## Appendix 5 – Lead Local Flood Authority

# 4848 – Barnsley West Drainage Strategy Meeting with LLFA

MAIN INFRASTRUCTURE DRAINAGE STRATEGY SHEET 1

### Points of Discussion - Notes from Meeting in Red

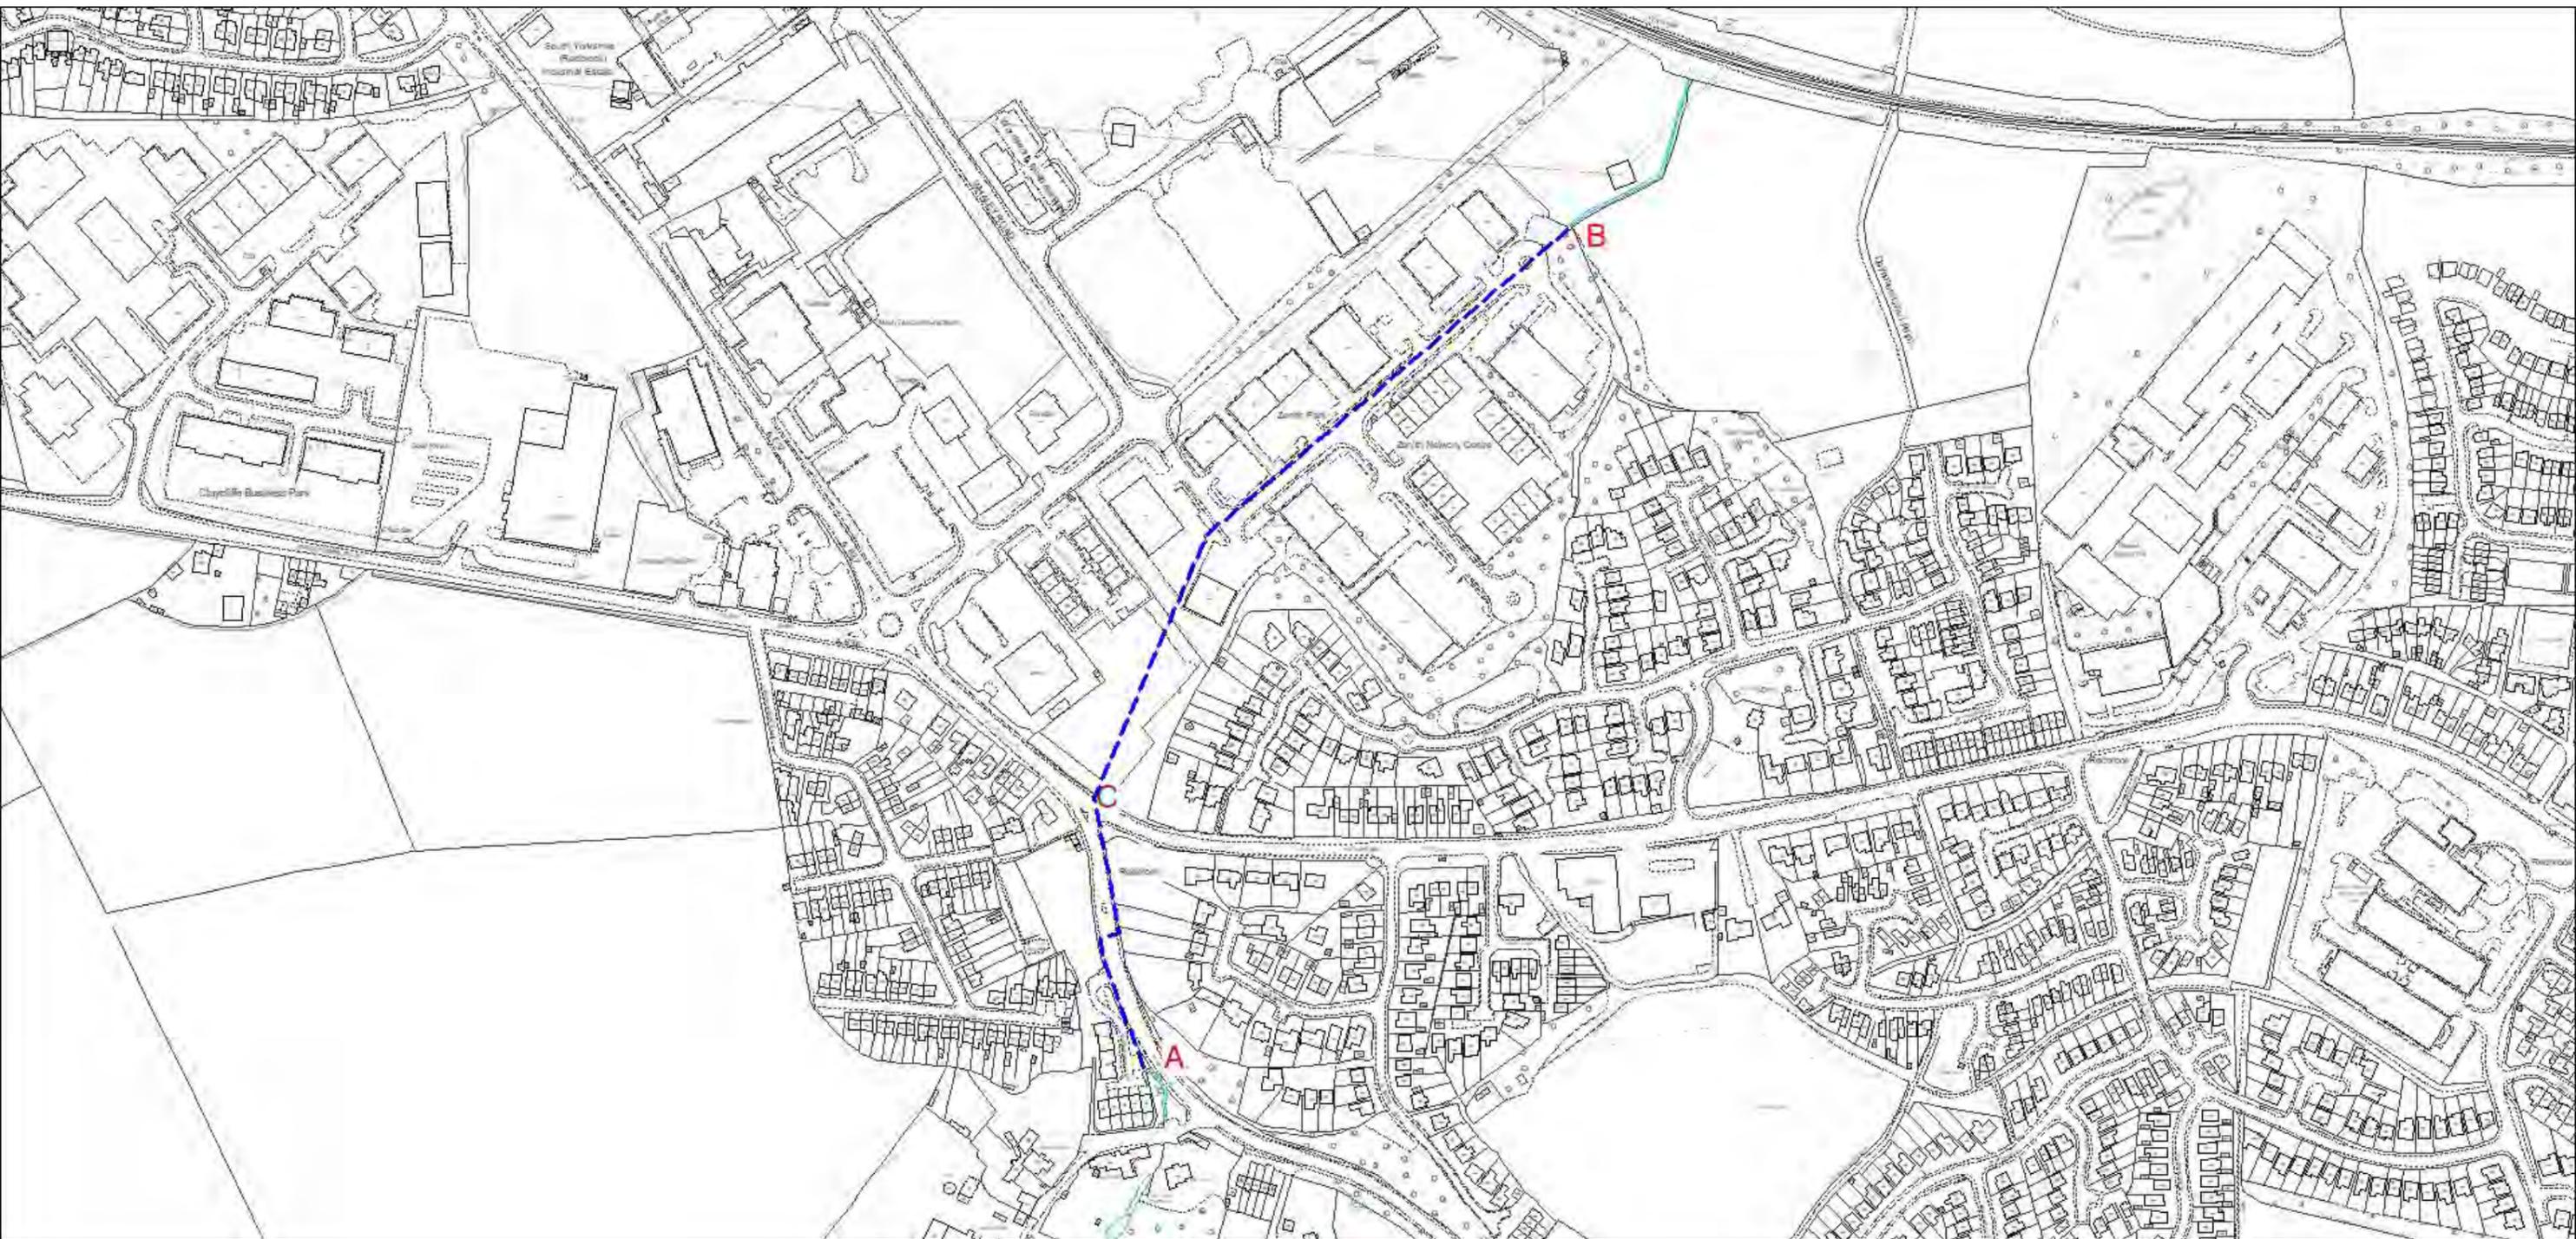
1. Discuss and agree discharge rates and/or method of calculation. Assumed greenfield run off rates preliminary calculation provided for information. **Greenfield run off from the plots can be calculated using a recognised method i.e., ICPSUDs or IH124 for example.**

2. BMBC historic information on the existing drainage network i.e., issues with flooding and operational problem downstream off the site etc. We have walked the open section as far as the weirs near Redbrook Road. However downstream of this it is unclear where the network then goes to get into the river. We are assuming that it is culverted for some or most of the route. **BMBC confirmed that there are capacity and structural issues with the culvert downstream of Redbrook Road and where the culvert runs beneath Zenith Park Industrial Estate. BMBC confirmed that there is major flooding here and as such direct connection into the on-site water courses for the development runoff even at greenfield rates would not be acceptable. This was communicated to Strata in a pass a planning strategy meeting. As such the restricted discharge from the site would need to connect into the open ditch section to the north east of Zenith Park Industrial Estate. BMBC accept that the section from the new roundabout on BGR to the open ditch section would need to be culverted/piped.**

3. Can you provide details of any highway drainage infrastructure in the public highway road network within and around the site and advise on outfall locations, capacities, and any issues? **There is a known highway drain in Baugh Green Road located in the northern footway. This has limited capacity. The proposed roundabout is to connect into this as per previous discussion with BMBC. This ultimately discharges into the water course to the west of Aldi and then running approximately north and is culverted beyond Aldi. Here there is also major flooding beyond Aldi. As agreed, as part of the previous submission by JPG that drainage from the new roundabout on Higham Common Road to connect into the existing highway drain in this location.**

4. Discuss and agree principles and points of discharge? High level strategy drawing provided detailing proposed location for attenuation basins and anticipated flows. **Points of discharge refer to item 2 comments. The principle of attenuation basins for the storage of surface water is acceptable to BMBC. However, they have concerns over the siting of Basin F been next to and higher than the existing housing. They have requested for the developer to look at relocating this basin further away from the boundary or relocating this somewhere else. Relocation of the basin to the northern end of the site may address this but you would then be adjacent to the new housing proposed adjacent to BGR. Design team to review.**

5. Discuss the proposed location of attenuation basins and exceedance design criteria. What designing criteria should we be working to in terms of volumes and exceedance events? **BMBC confirmed there have no knowledge of any official guidance national or local that we would be expected to adhere too. However, principle discussed for an exceedance event would be that the basins would be required to retain the 1 in 100 YSE plus 40% CC and a minimum free board of 0.500m would be required above this level. Water level above this would be allowed to discharge back into the existing water course system in a controlled manor. JPG to provide calculation to confirm what storm event could be held in the basin up to the top of free board. Some form of control to allow water to spill above this level would be required. Maybe short section of weir to limit run off. Discharge back into the existing water courses would be to avoid scour of the existing watercourse.**

6. Discuss and agree how exceedance flows would be dealt with from the development. **See comment in item 6 above.**
7. Discuss and agree requirements for attenuation basins and other SuDs features if not to SuDs manual criteria? **Any SuDs features should be design as a minimum to SuDs manual criteria and requirements.**

8. Discuss options for adoption/maintenance of the basins and other SuDs features. Infiltration is not going to be feasible. Potential issues with YW taking these as the design criteria is onerous and as such developer would like to try and avoid this route if possible. Would the likes of BMBC, or private management company or some other body like a wildlife trust for example be acceptable to be responsible for these subject to negotiations? Incorporation of SuDs should be first option, but issue as always is who will maintain these. **BMBC confirmed that they would not take on the operation and maintenance of the basins. There acknowledged the issues we would likely have with YW and this was also discussed in the planning strategy meeting which YW attended who were non-committal on the adoption of SuDs in general even though this is now part of the CODES guidance document. BMBC do not like private management companies due to past issues on other schemes. But is there was no other option then this route would be acceptable. However, they would need to see from the developer how this would work, how this would monitor and that maintenance etc was been carried out and who would ultimately be liable if the management company went bust for example. BMBC are very nerves because of the location of basin F and adjoining existing houses. If the pond overtopped and the cause was due to lack of maintenance where would everyone stand in terms of liability?**

9. Discuss and agree principles for dealing with the runoff from existing land drainage, we know there are some springs on the site and others may be located during the earthworks (discharge rates and methodology for dealing with these etc.). **BMBC confirmed that the principle of redirecting any existing land drainage what needed to be dealt with after the earthworks and connecting this back into the existing watercourse was acceptable. Run off from this would unrestricted via suitable SuDs features i.e., ditches and filter drains etc. However, to minimise scour the existing land drainage run off should be discharged where possible evenly into the water course. A large outfall collecting big areas would not be acceptable.**

10. Discuss and agree principles for dealing with the runoff from the landscaped areas and large embankments which will be created as part of the earthworks exercise (discharge rates and methodology for dealing with this). **BMBC confirmed that the principle of redirecting any runoff generated from the proposed banks and connecting this back into the existing watercourse was acceptable. Run off from this would be restricted to greenfield run off or equivalent run off from embankments. BMBC said that they recall they used to be a calculation in DMRB to work out run off from slopes and embankments. JPG to review this and advise. It is likely that item 9 and 10 would be a combined system in some of all the locations.**

11. Discuss and agree principles for dealing with temporary drainage once the development platforms have been formed and prior to any houses or commercial buildings been constructed. **BMBC agreed that control of run off from the development platforms prior to construction of the dwellings and commercial units needed to be considered. Whether it was possible to produce a design to cover the entire site at this stage was debatable, and it was likely this would be a moving target. However, principles could be agreed on methodology what could be implemented by the contractor and to suit their phasing and programme. Things like mounds, ditches, filter drains to direct and collect run off and stilling/silt basins, silt fencing around stockpiles to control silt and bunding to fuel storage areas etc could be incorporated up stream of any discharge into the basins to control run off. The two main objectives would be to minimise silt getting into the attenuation basins and controlling the runoff as best possible.**
